Spartan™-IIE and Spartan-3 FTG256 Pb-Free Moisture Sensitivity Level Change

XCN06003 (v1.0) January 30, 2006

Quality Alert

Figure 1: Example Package Top Mark

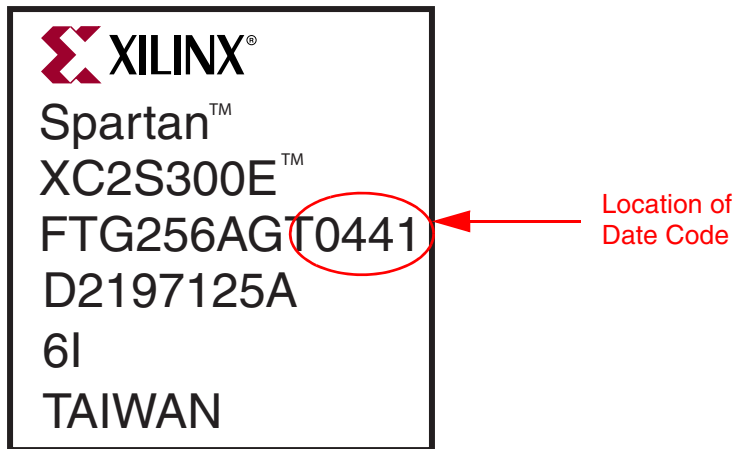
The date code traceability for conversion back to Level 3 per [Table 1](#) can be found on the package top mark. [Figure 1](#) illustrates an example of the top mark.
